Omaha Public Power District

May 17, 2005
LIC-05-0062

SUBJECT: Fort Calhoun Station Unit No. 1, Response to Request for Additional Information on the Revised Relaxation Request for First Revised Order (EA-03-009) Establishing Interim Inspection Requirements for Reactor Pressure Vessel Heads at Pressurized Water Reactors

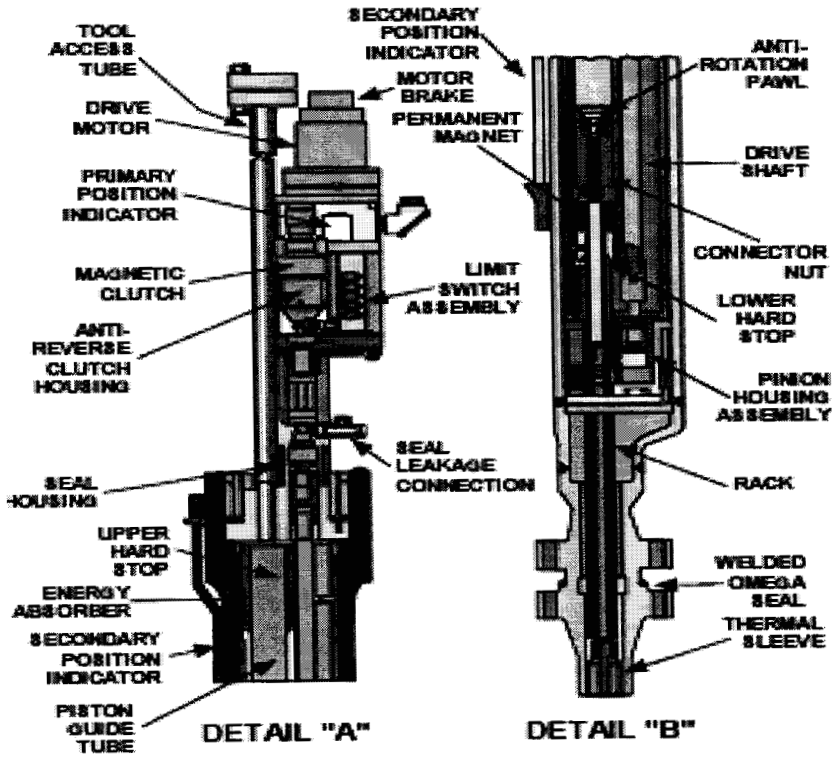
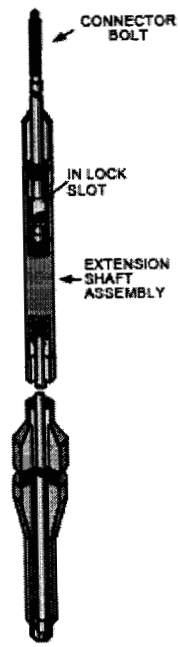
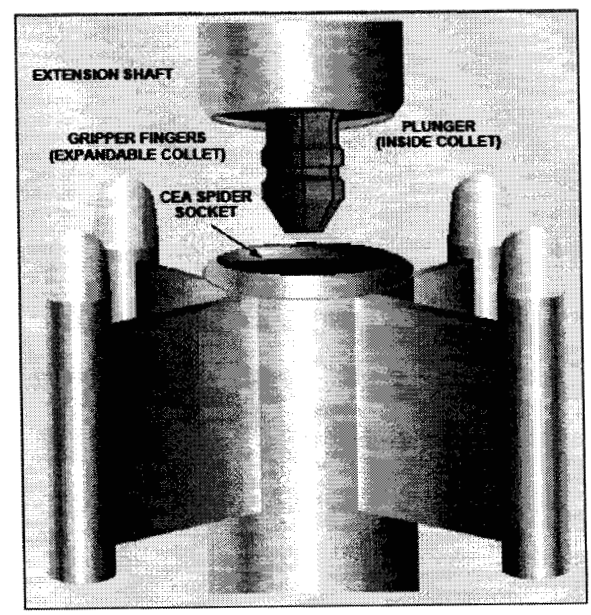
Please provide a detailed explanation of the hardship associated with removal of the thermal sleeve for Control Element Drive Mechanism (CEDM) penetration nozzle 25.

The rod control system at Fort Calhoun Station Unit No. 1 (FCS) is a unique design that uses a rack and pinion CEDM. Palisades is the only other plant with rack and pinion CEDMs, but their configuration under the reactor pressure vessel (RPV) head is very different from FCS, in that their CEDM extension shafts can be removed from the top. The rack and pinion design imposes a significant constraint on performance of a RPV head inspection because the CEDM extension shaft that connects the drive mechanism to the Control Element Assembly (CEA) remains installed in the RPV head nozzle when the reactor is disassembled. The presence of the CEDM extension shaft severely limits access to the nozzle inside diameter (ID) for inspection purposes. Inspection access is further complicated by the thermal sleeve that is installed in the annulus between the CEDM extension shaft and the CEDM nozzle.

FCS has a "scram weight" at the end of each CEDM extension shaft that precludes CEDM extension shaft removal from the top of the RPV head, necessitating their removal from below the RPV head (See Reference 1, Attachment 1, Figure 3, Page 15). Palisades does not have these weights and can remove their extension shafts from the top of the RPV head.

The basic component arrangement of the system is shown in Detail "A" (upper components) and Detail "B" (lower components). The components of interest in this discussion are as follows:

- Extension shaft assembly – supports the CEA spider
- Connector bolt – supports the extension shaft assembly
- Connector nut – supports the connector bolt
- Rack raises and lowers the rack extension to raise the CEA

The CEDM extension shaft assembly is inserted through the CEDM nozzle from underneath the RPV head and extends through the rack into the piston guide tube.

In order to remove the CEDM extension shaft on CEDM nozzle 25, the RPV head will be installed on the reactor vessel and the CEDM extension shaft will be lowered until it rests on the CEA spider. The CEDM connector nut will then be removed and the reactor head will be lifted and placed on the head stand. It is anticipated that the CEDM extension shaft will be left resting in the Upper Guide Structure in the reactor vessel. However, since this operation has never been performed, it is not certain that the CEDM connector bolt will disengage smoothly from the CEDM rack assembly and slide downward while the RPV head is being lifted. Additional rack extensions may need to be removed to gain proper clearance and a pathway to access CEDM nozzle 25.

With the CEDM extension shaft(s) removed, the RPV head will be placed in the head lay down area. The configuration of the thermal sleeve cutting equipment requires the RPV head to be raised approximately two feet above the normal resting height. Due to the tight clearances in this area, this additional two feet of height will require removal of interferences and rotating the RPV head into an off-normal orientation. The thermal sleeve will be cut above the CEDM nozzle inspection area and removed. The cutting operation will be performed using precision cutting equipment to avoid any possibility of damage to the CEDM nozzle ID. Industry experience has shown, however, that there is a risk of introducing tool marks on the ID of the nozzle. Special cutting equipment is required to perform this operation because the thermal sleeve will be cut approximately 24 inches above the bottom of the CEDM nozzle. Once the thermal sleeve has been cut and removed, additional special tooling will be used to reinstall the original "flare" on the remaining end of the thermal sleeve. The flare is required to prevent interference with the CEDM rack as it raises and lowers the CEA.

Attachment 1, Figure 1

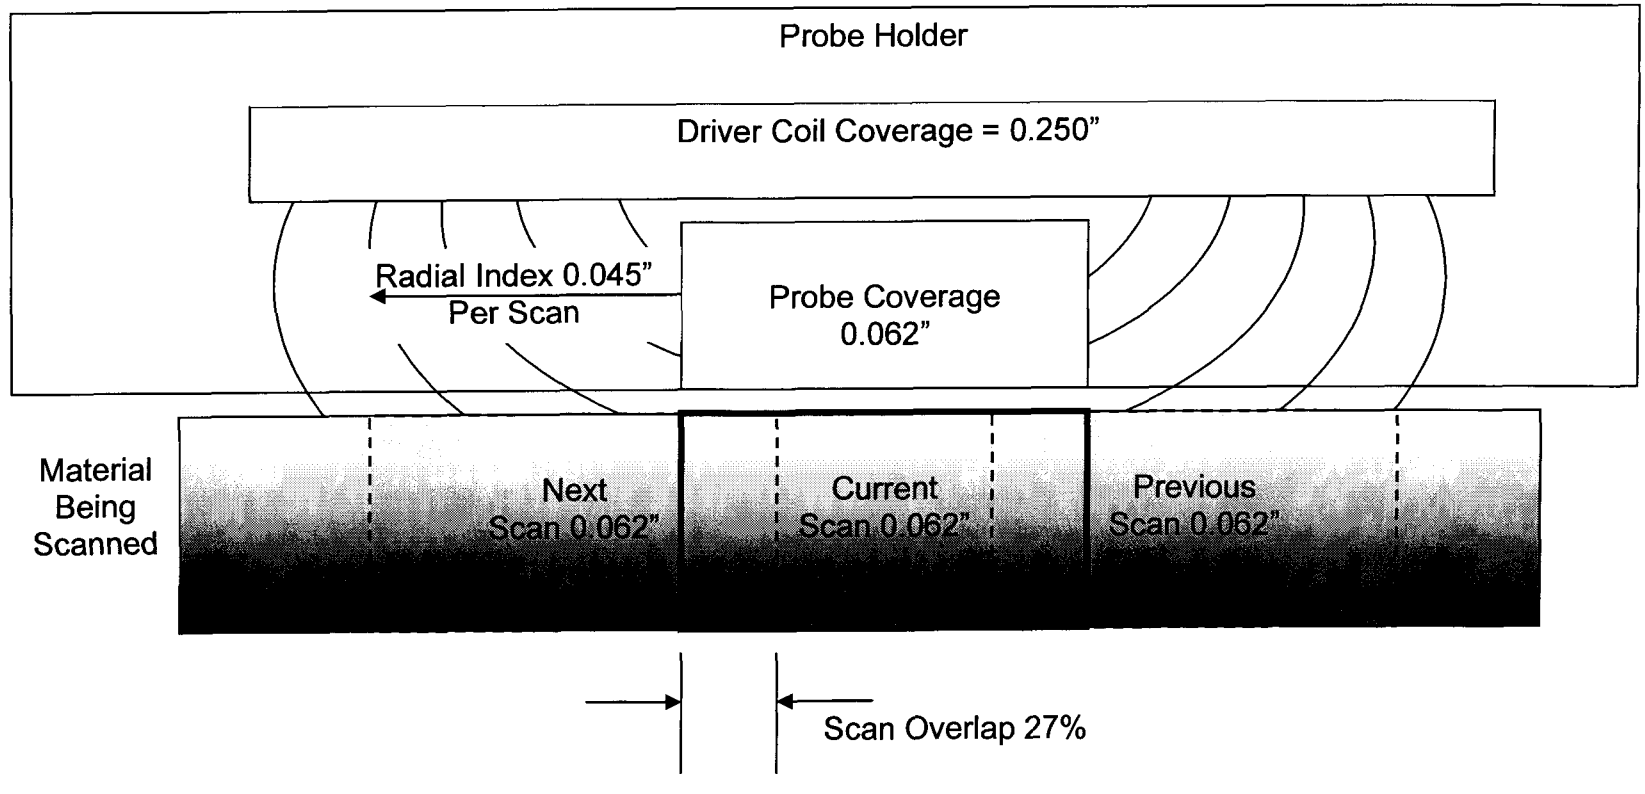
Please provide a detailed explanation to support the position that missing a single scan line is acceptable.

Various CEDM nozzles have single missing scan line information in some areas. OPPD has determined in each case that a single missing scan line does not prevent determination of a potential significant flaw, due to the amount of overlap of adjacent scan line coverage in adjacent eddy current traces. These areas are considered to be fully inspected.

The geometry of the probe and driver coil in combination with size of the scanning grid and the defined overlap ensures that any indication, regardless of width or length, will be observed. Adjacent scan lines have an overlap of 27% as shown on Figure 1. This criterion is based on the number and location of sensors in the probe and the overlapping regions of sensitivity resulting from the scan line increment assuring that a valid indication of relevant length should be evident. An indication picked up in one scan line will also be seen by the adjacent scan lines. A missing scan line is most likely caused by small boric acid on deposits or crud accumulation on the nozzle or thermal sleeve surface which causes axial travel resistance on the probe.
